KMR.CDD.BuQ.1918-1919.01

PLAN SHOWING PROPOSED ADDITIONAL
SHOPS TO THE MARKET ON PLOT NO 2

SHEET NO A-13

BUNDER Q_R

Arch

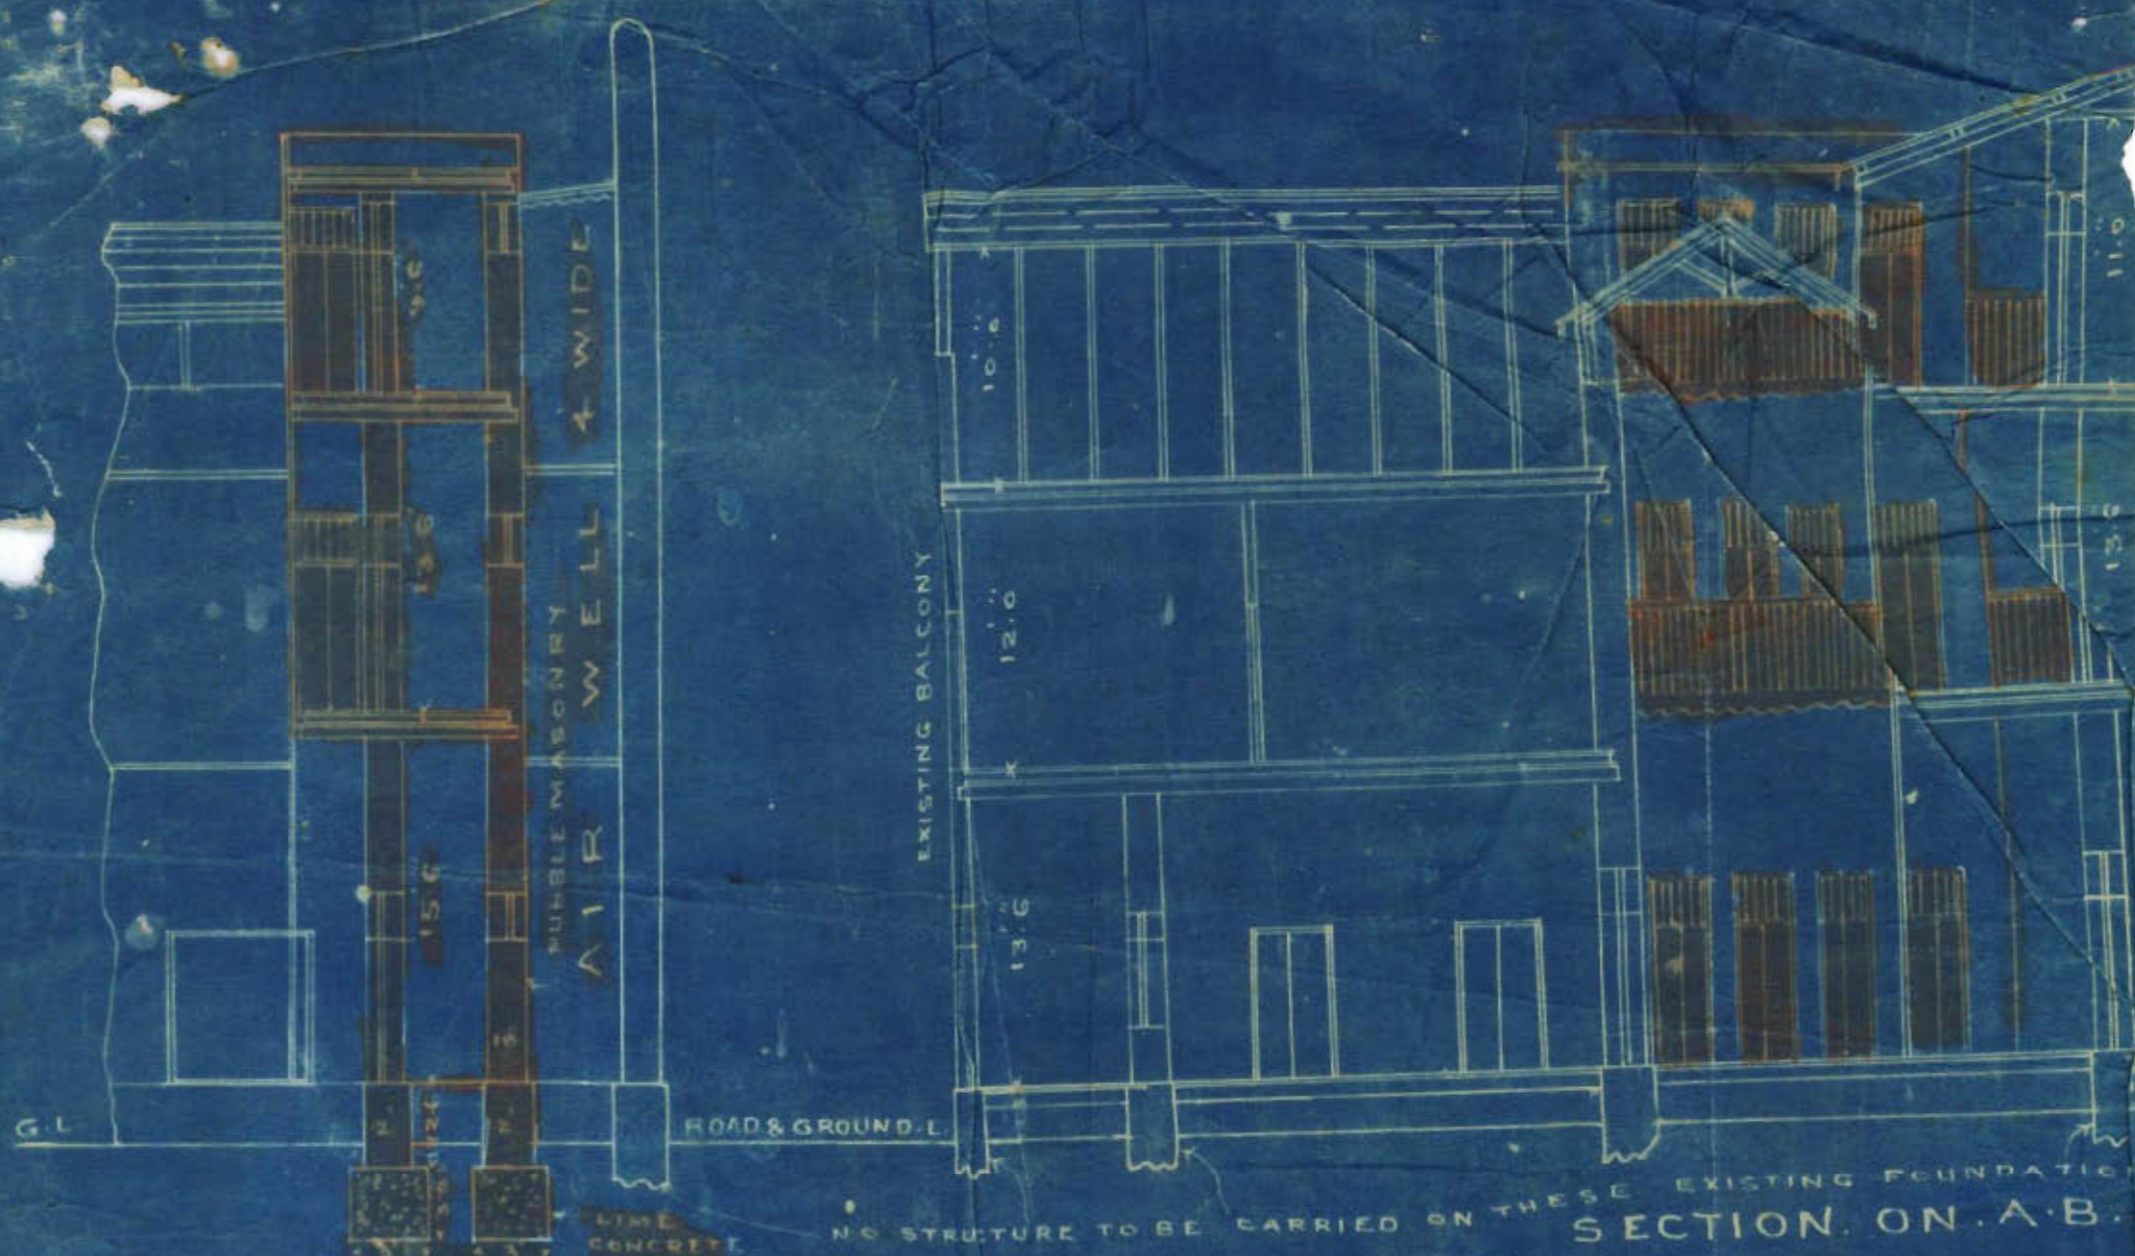
With reference to his additions and alterations to his building on plot No. 2.A-13 Bunder quarter Mr. Noormahomed Lallan is informed it is observed that he is deviating from the approved plan by reducing the number of water-closets and bath-rooms.

With reference to his additions
and alterations to his building on Plot No. 2 A/3
Bunder Dr. Mr. Noormahmad Lalani is
informed, it is observed that he is deviating
from the approved plan by reducing the number
of W.C.s & bath rooms.

With reference to his application dated 20th August 1918 with plans of the proposed shops to be built on plot No. 2.A-13 Bunder Quarter Mr. Nurmahomed Lallan is informed that permission to block up the present entrance which provides ventilation to the building cannot be permitted.

Permission to block up the present
entrance which provides ventilation
to the building cannot be permitted.
The plan is disapproved.

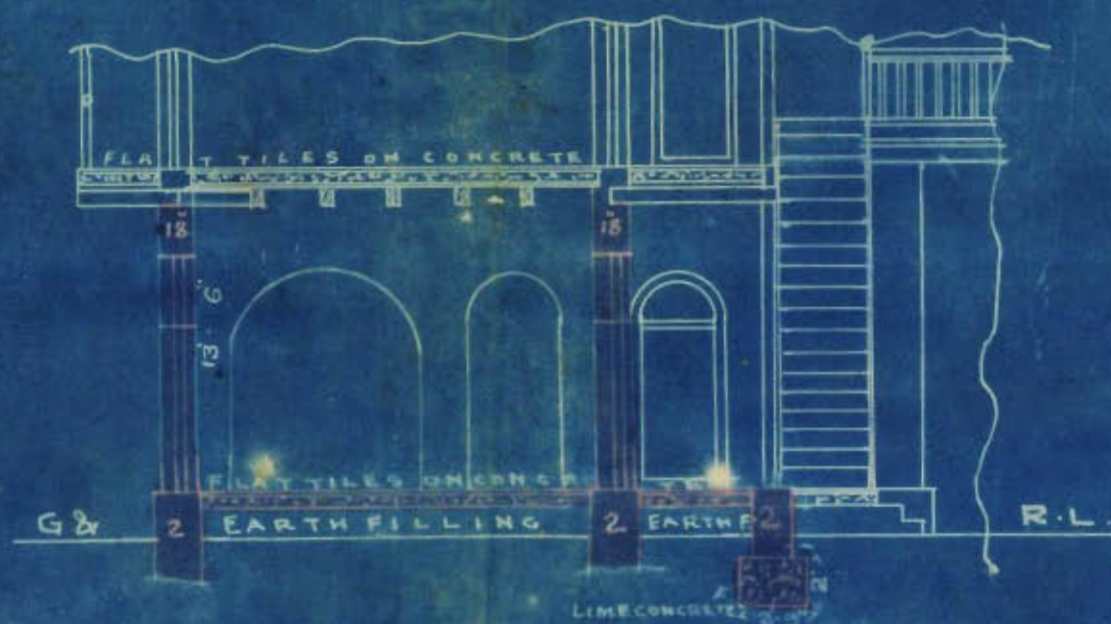
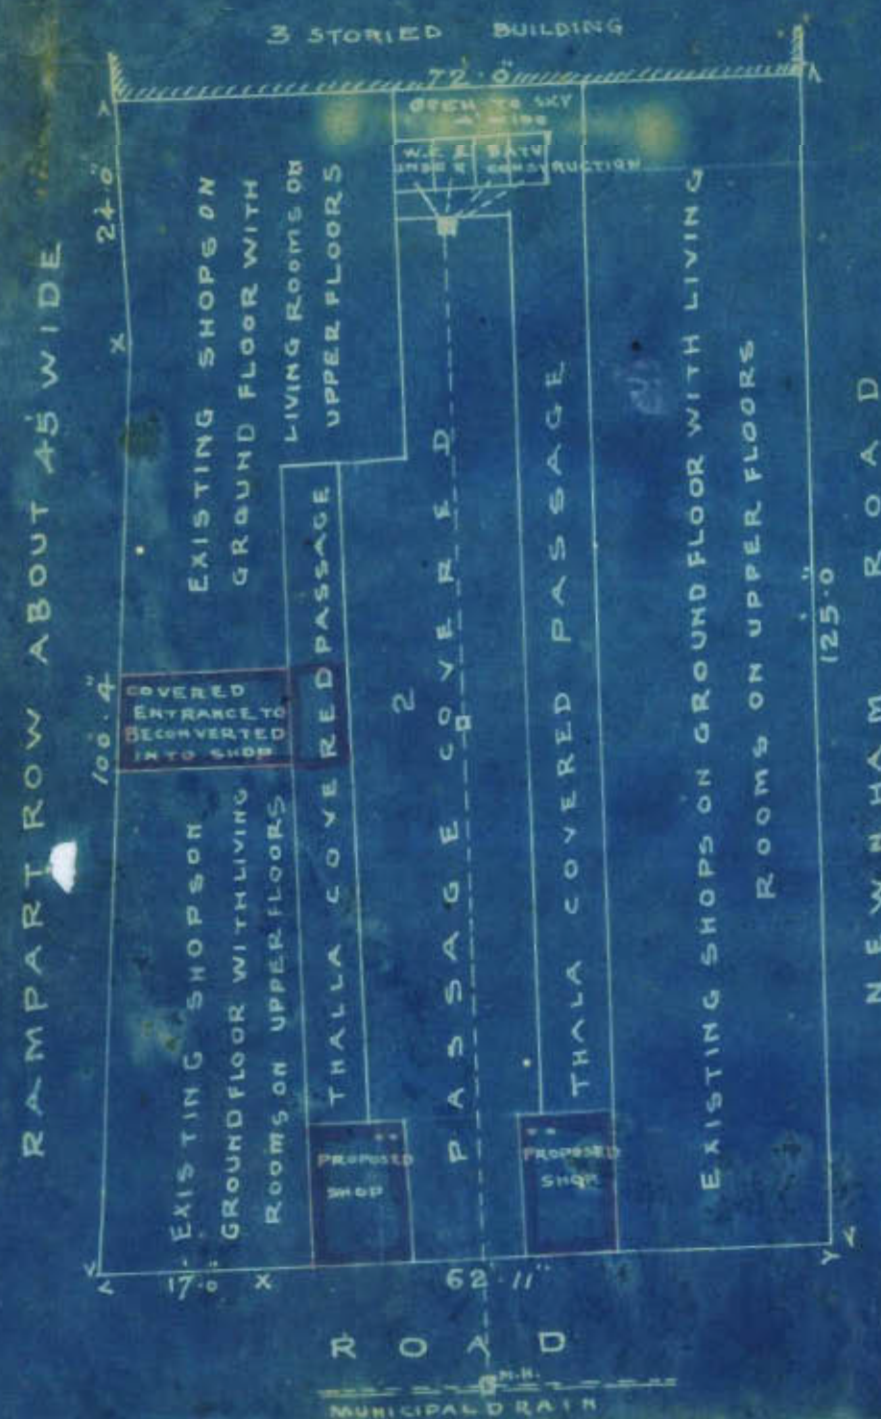
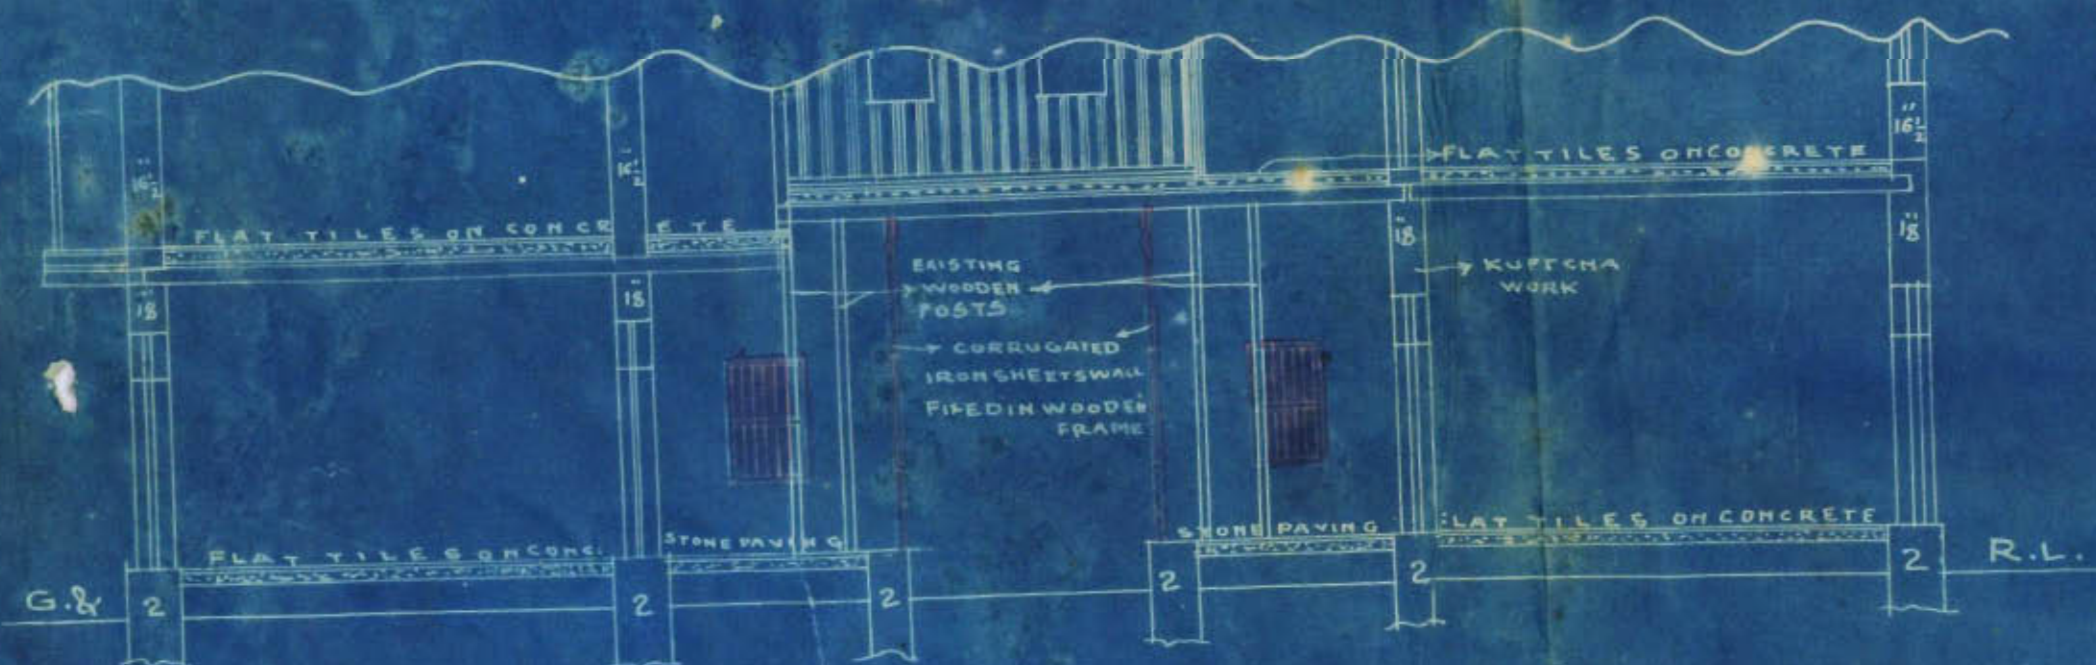
Proposed shops will interfere with the existing ventilation of the market, which is already defective. Permission therefore should not be granted.

They expect that the proposed shop will
make the building unsanitary by blocking up
the ventilation

Remarks Sir With reference to this they hope
that the gate way should not be allowed
to convert into shop as thereby the present
ventilation will be blocked up.

In reply to your memo No: 1509 dated 13/18th instant I have to state that I do not want to build a shop in such a way as to block the present entrance for ventilation as you seem to think, on my plot No: 2 Sheet A-13 Bunder Quater Rampart Road Karachi. ~~Ixxx~~ I simply want to remove a wall and erect an arch instead and thus make a new shop. Besides this some immaterial alterations have to be made in the shop ~~forxxxx~~ as for instance putting ~~xxx~~ wooden shelves &c for the convenience of the tenants, and to substitute one window by a door. You will thus find that the ventilation will on the contrary be more than what it is at the present moment.

DISAPPROVED
